ADDENDUM NO. 4

PROJECT NAME: Stinson Park Improvements Project

DATE: 08/23/13

CIMS PROJECT NO.: **40-00309**

Date: 07/23/2013
 Project No. 2130496
 Sheet Title: SITE PLAN
 Drawing No. C4.00

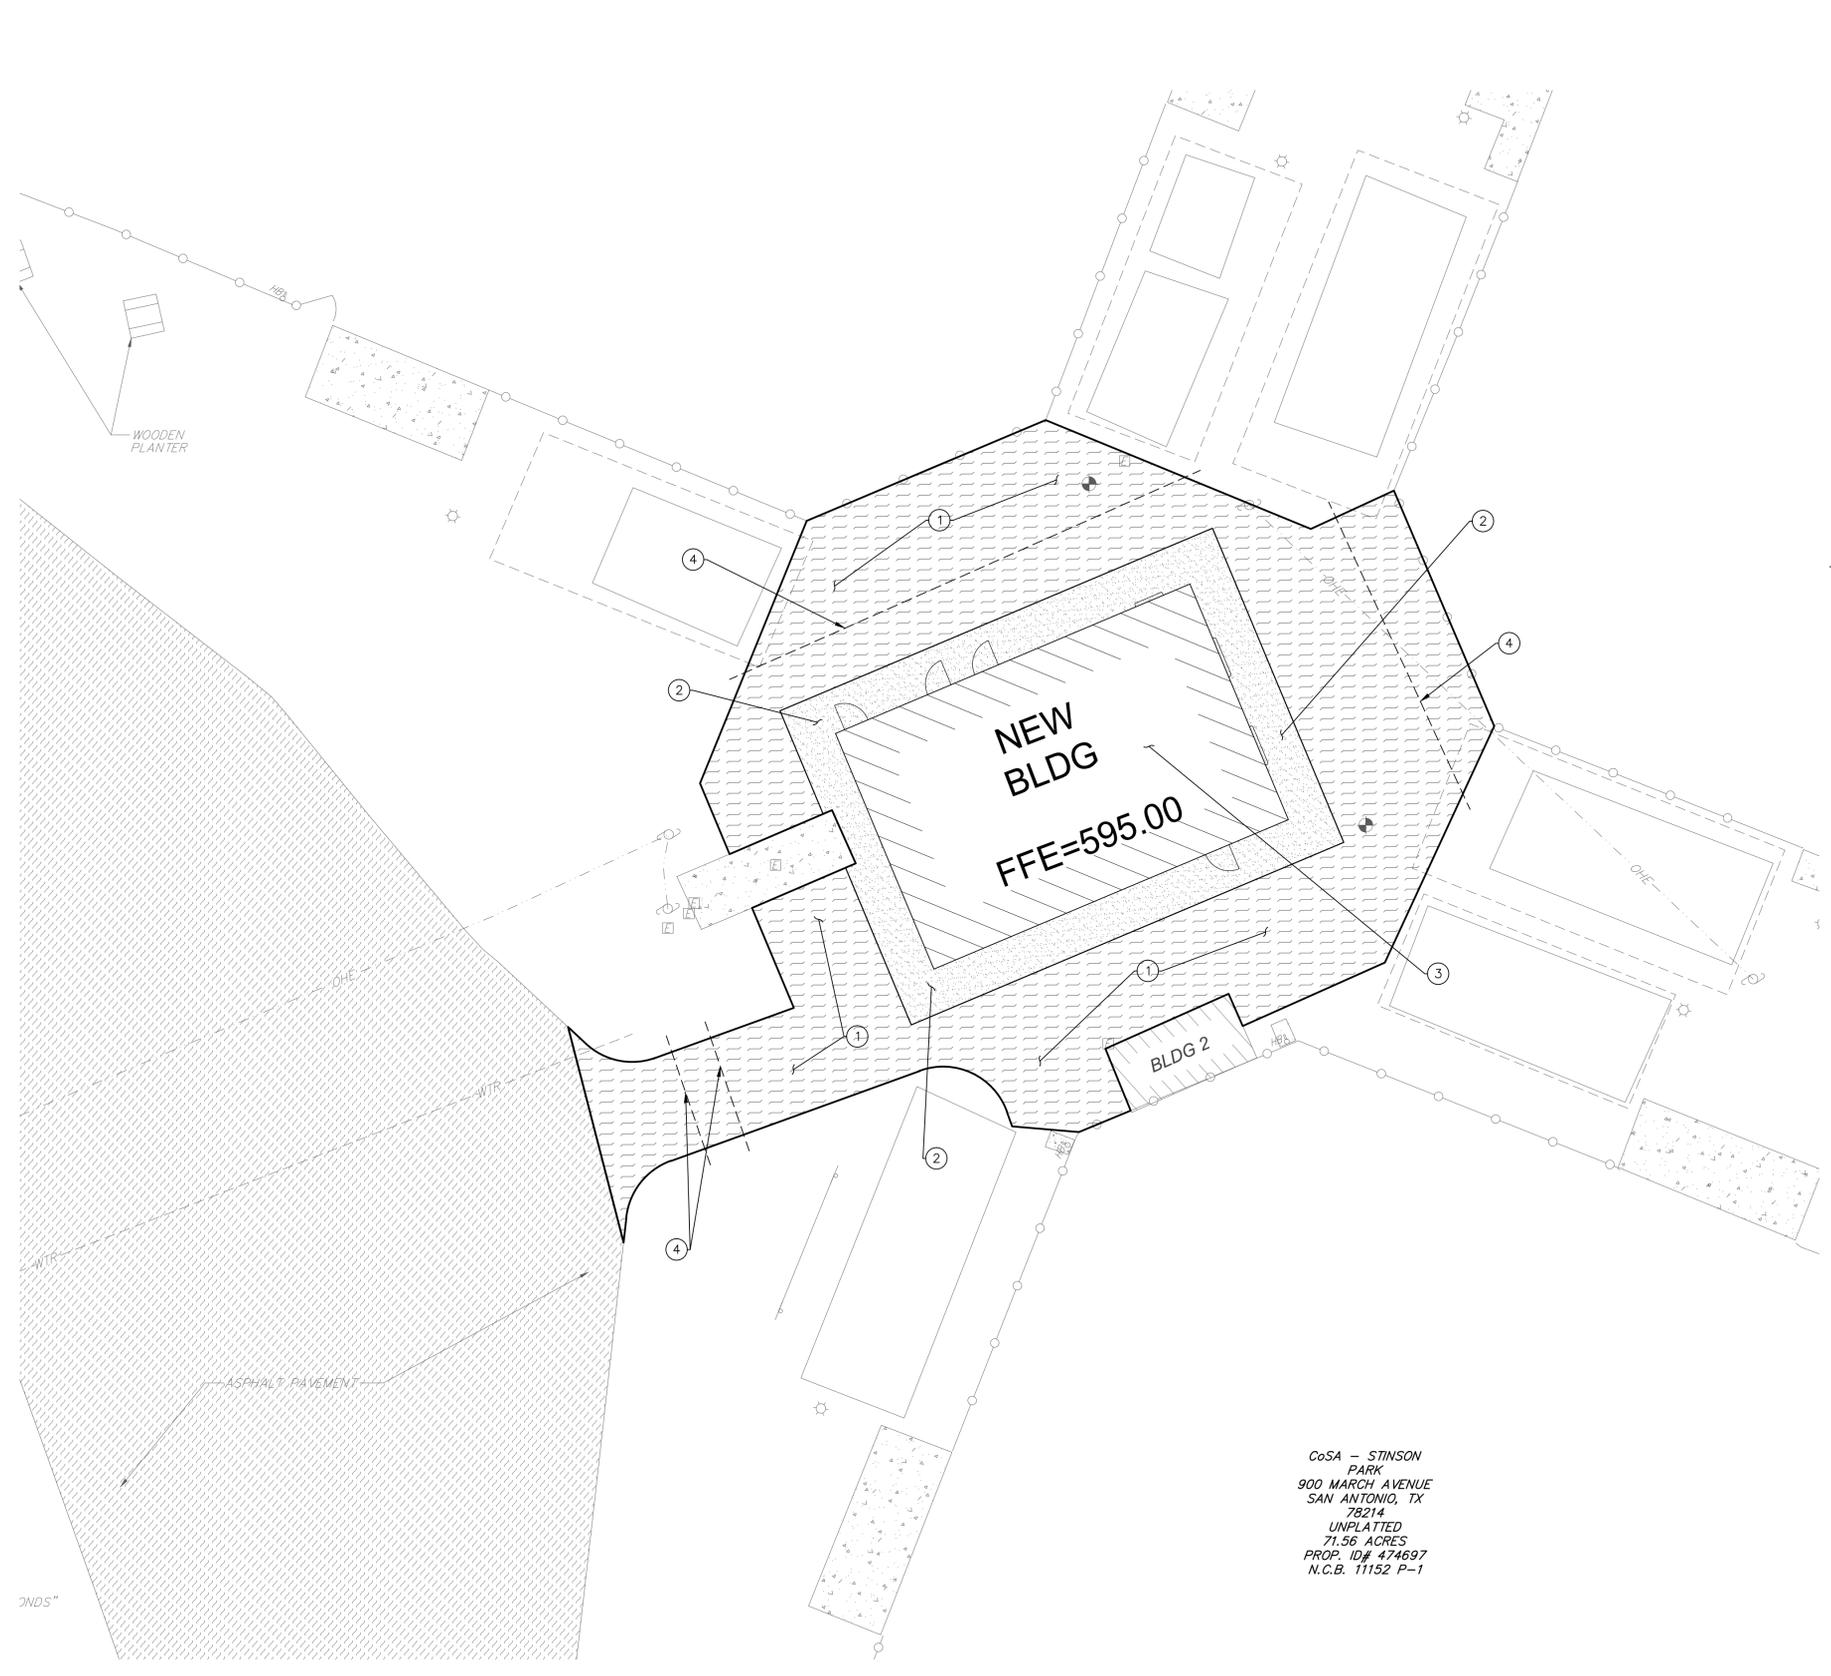
1. Completely delete sheet P1.1 from the bid set drawings. Grease interceptor is included in the RFL allowance figure.
2. Revised underground utilities plan attached. (8-1/2 x 11)
3. Replace sheet C4.00 – Site Plan with revised sheet C4.00. Added Building Pad Preparation note #4, referencing the vapor barrier requirement.
4. Replace sheet C5.00- Utility Plan with revised sheet C5.00. Reduced SS lateral connections, removed grease trap.

REVISIONS:
 08/23/13 - ADDED BUILDING PAD PREPARATION NOTE

④ CONTRACTOR SHALL PROVIDE A 15-MIL VAPOR BARRIER FOR THE CorWorth INSTALL CREW. VAPOR BARRIER IS TO BE PLACED BETWEEN THE LEVELING SAND AND BUILDING SLAB.

Date: 07/23/2013
Project No. 2130496
Sheet Title: UTILITY PLAN
Drawing No. C5.00

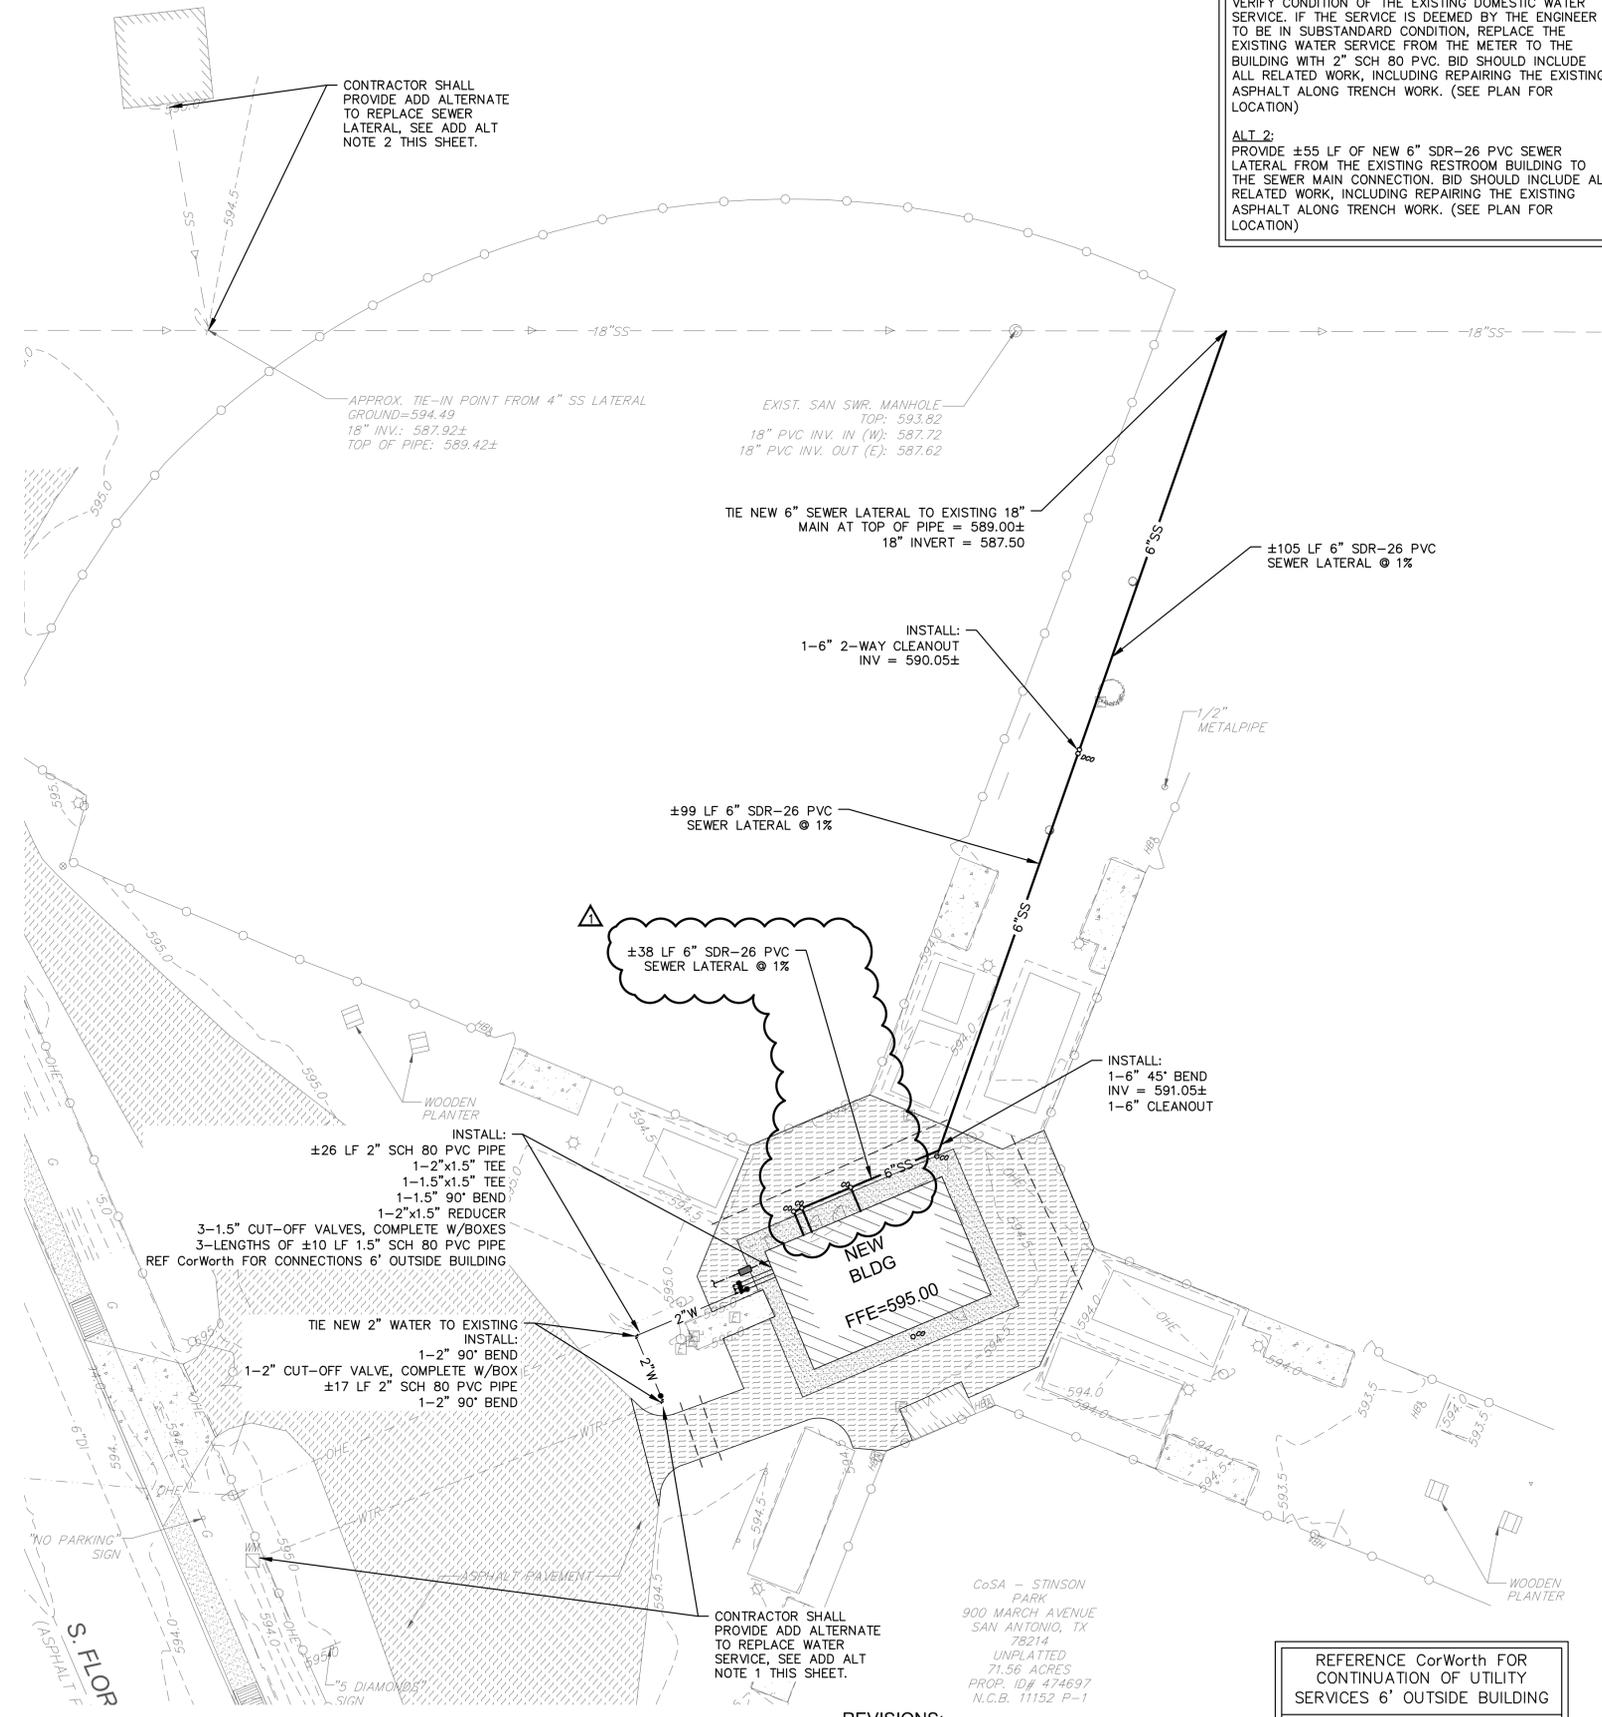
REVISIONS:
08/23/13 - REDUCED SEWER LATERAL CONNECTIONS,
REMOVED GREASE TRAP
